**AN ORDINANCE OF THE CITY OF WESTFIELD AND WASHINGTON TOWNSHIP,
HAMILTON COUNTY, INDIANA CONCERNING AMENDMENT TO TITLE 16 –
LAND USE CONTROLS**

Summary of Comments on Harmony PUD Ordinance - Comments_053112.pdf

HARMONY PUD TABLE OF CONTENTS

Exhibit C – Illustrative Plan

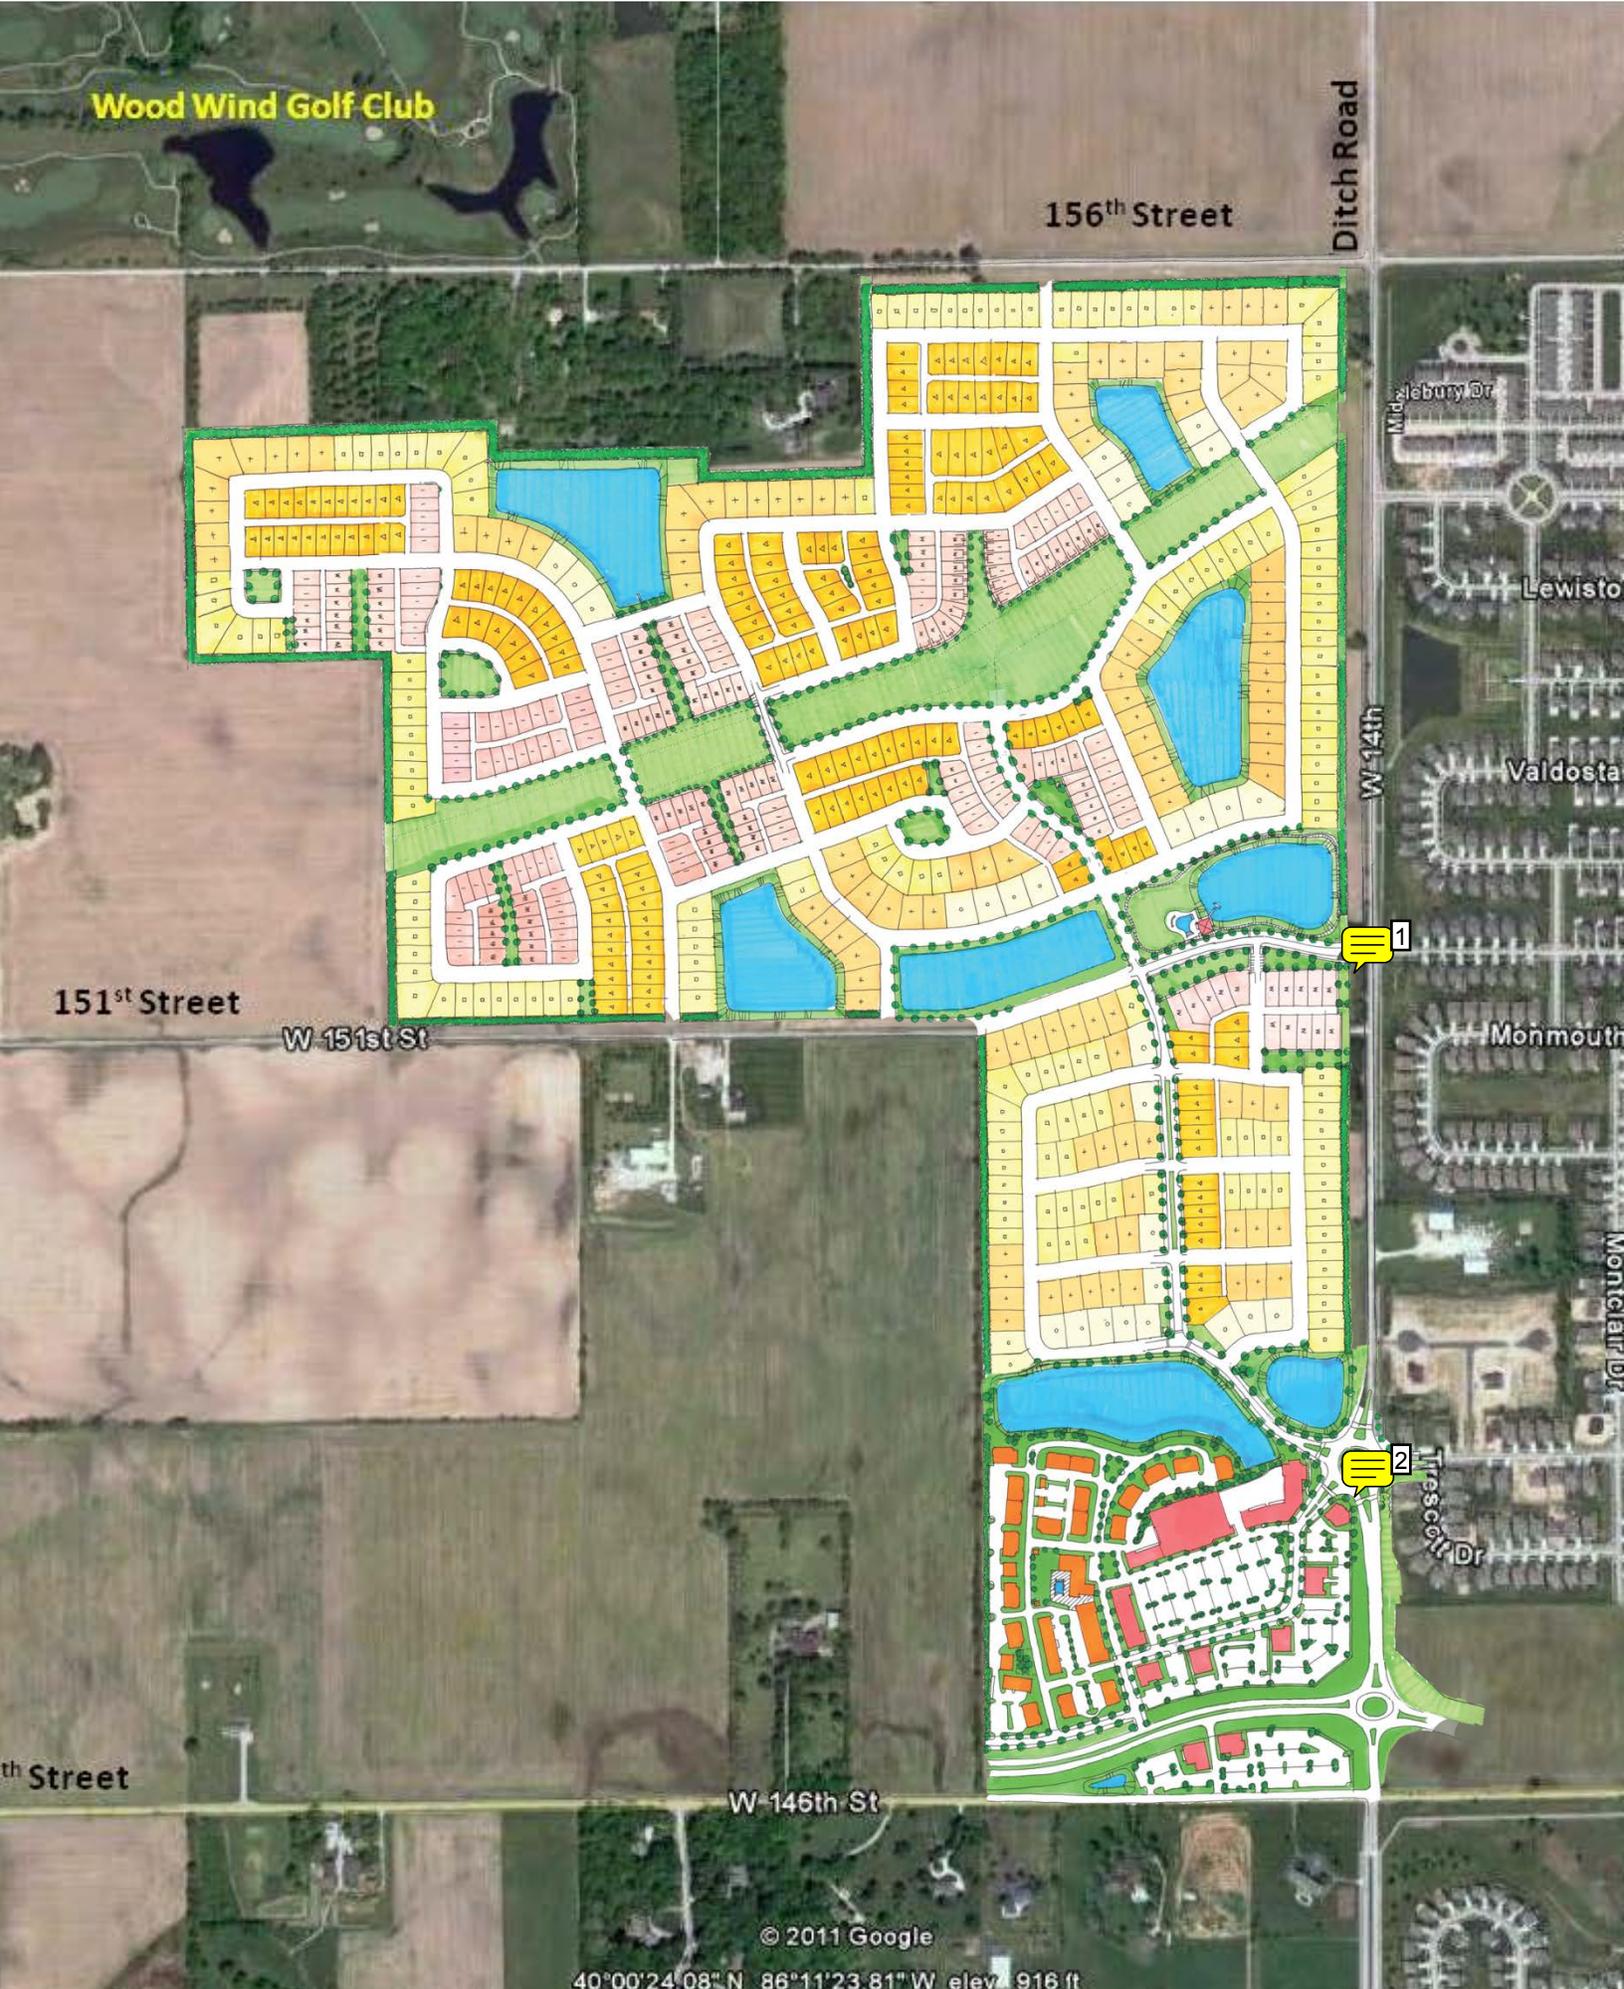
A safety concern has been expressed for pedestrians crossing in the 5-point round-about. Please explain/show pedestrian crossing plans for this round-about.
